YARRA CITY COUNCIL

Internal Development Approvals Committee

Agenda

1.1 314-320 Swan Street and 236 Coppin Street, Richmond - PLN16/0034

Comments regarding proposed demolition:

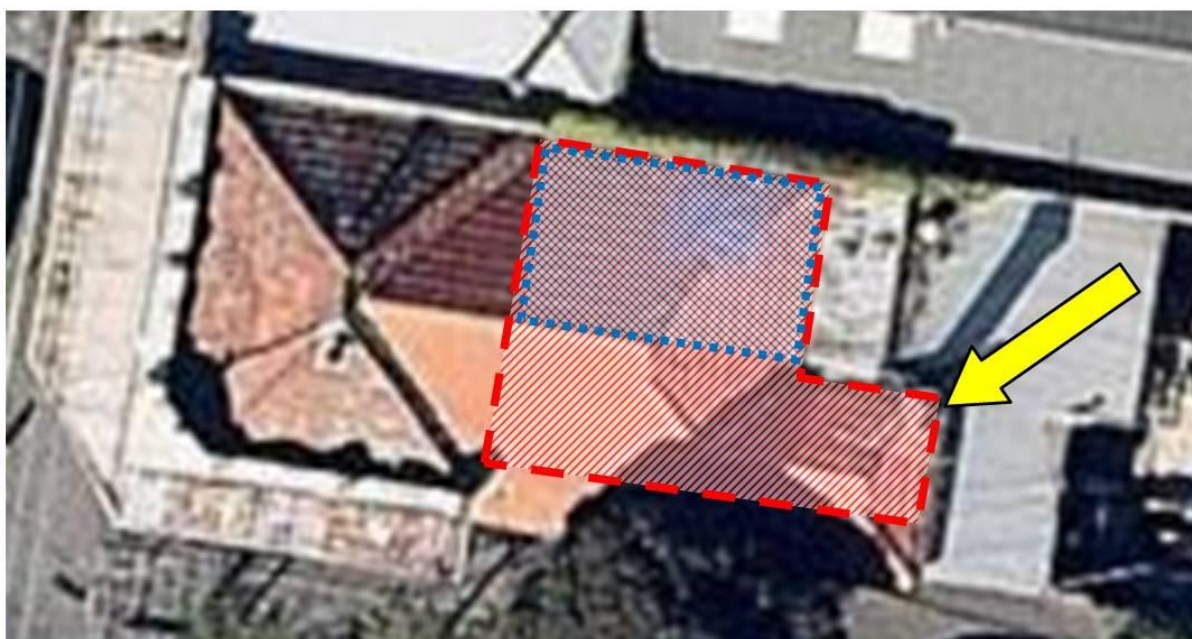
The extent of demolition proposed by this application includes the demolition/removal of all of the built form and structures beyond the extent of the original red brick structure fronting both streets.

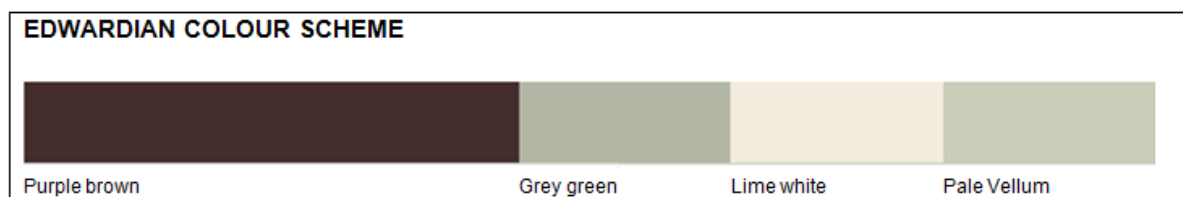
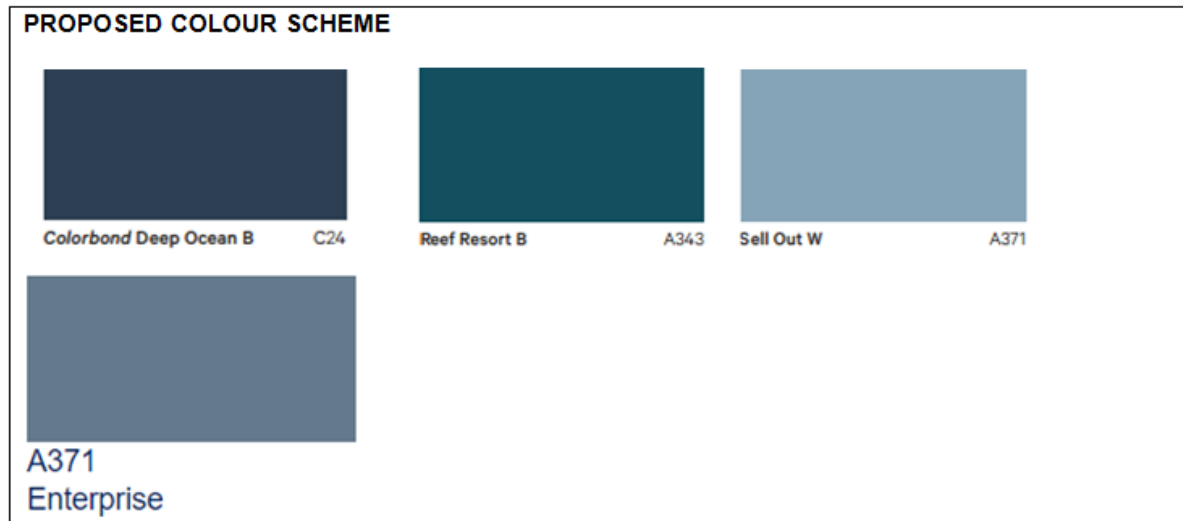
A conservative design approach has been adopted for the proposed development. This approach is considered acceptable as adequate respect is given to the heritage character of the surrounding area through details such as external materials, proportions and fenestration.

The proposed external materials for the new development will be painted render and painted face brickwork. Although the materials are considered acceptable, the colours proposed are not considered sympathetic to the predominantly Edwardian period streetscape along Myrtle Street.

Attachment 7 - PLN15-0645 - 54-56 Bridge Road Richmond - Urban design unit comments

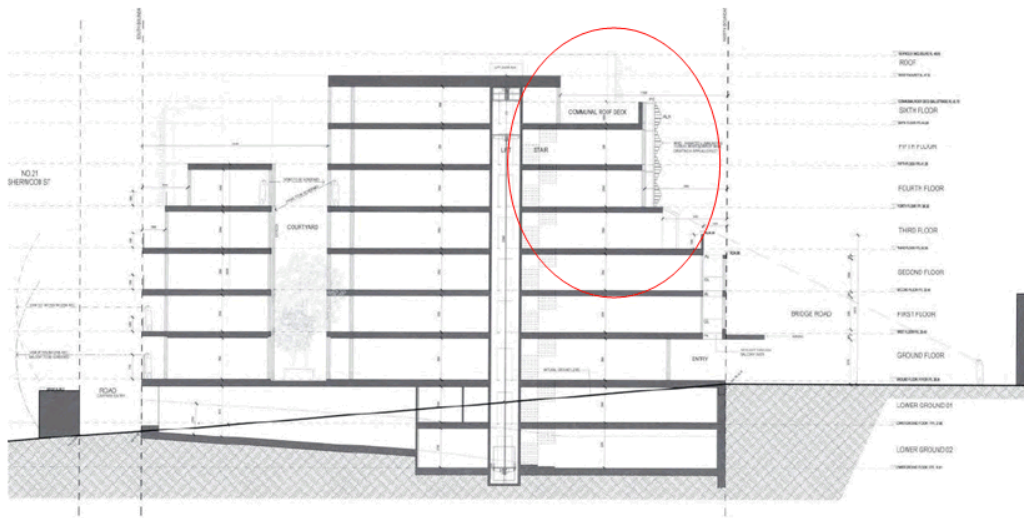
The design proposes a setback of about 5.5 to 5.8 m for the eastern block and a set-back of about 8 meter for the western block. The view line diagram above indicates that the third, fourth and fifth floors will be highly visible making the upper floor looking very dominant above the 3 storey street wall. To reduce the height impact of the building it is felt that east and west sections of the buildings are aligned and the eastern section of the building is set back to about 8 meters to be in line with the western section. The seventh floor needs to be further setback to avoid any height impact.

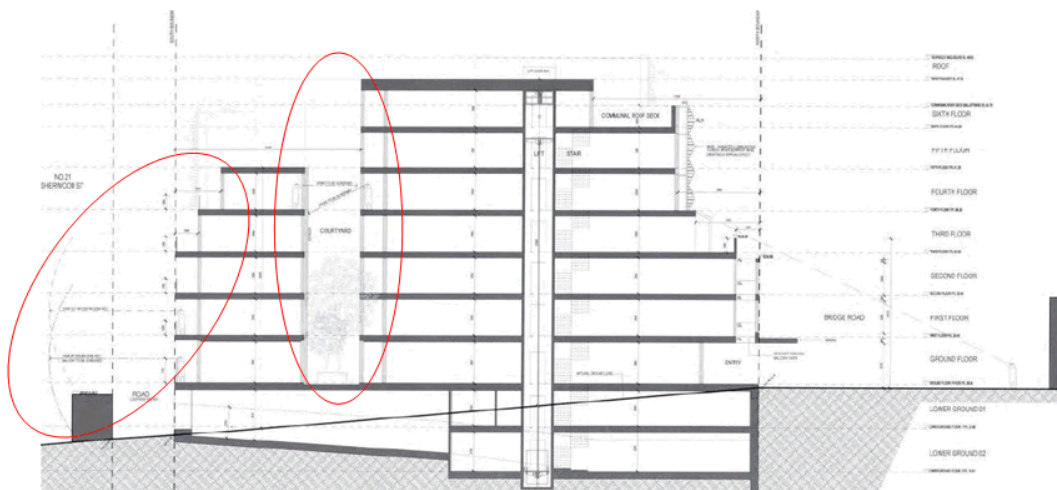
The layout also proposes two staggered courtyards in the middle. There are concerns with these courtyards as they will be surrounded by 5 storeys in one case and 7 storeys in the other. This will have an impact on the solar access to the adjoining bed rooms. It is recommended that the building on the northern side of the western courtyard should be set back above the third floor at the courtyard interface, so that there will be more sun light to the courtyard and the balconies at that interface should be removed.

Figure 1 – Indicative building envelope following recommended northern and southern setback amendments. Red depicts deleted form (Source: Wall Architects, with emphasis added)

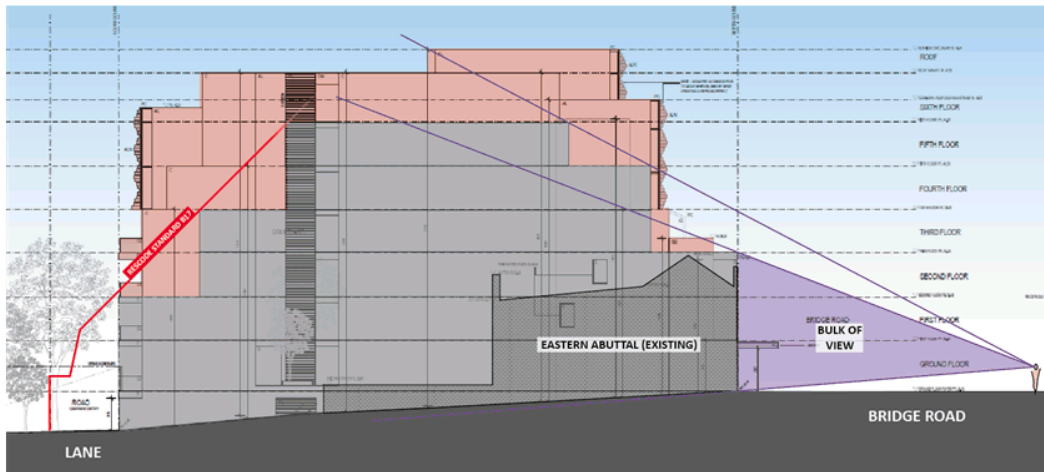
The extent of upper form street setback will result in an overtly dominant mass within the context of the heritage streetscape of Bridge Road. It is recommended that the upper form of the proposal be set back to Bridge Road in accordance with Figure 1 below, in which the upper form is to constitute a small percentage of the overall visual experience of a pedestrian situated on the

northern Bridge Road footpath. This will facilitate an outcome that will respond appropriately to the streetscape and heritage characteristics of the subject site's proportion of Bridge Road in a manner that is commensurate with existing and emerging developments within the Bridge Road MAC.

Amended Plan Comments: The amended plans indicate a rear setback outcome that is consistent with the provisions of B17, which is technically consistent with the intent of earlier urban design advice. However, the architectural resolution of this setback bears little resemblance to that indicatively illustrated in Figure 1 (above) and is overtly driven by B17. It is recommended that the architectural expression is amended accordingly.
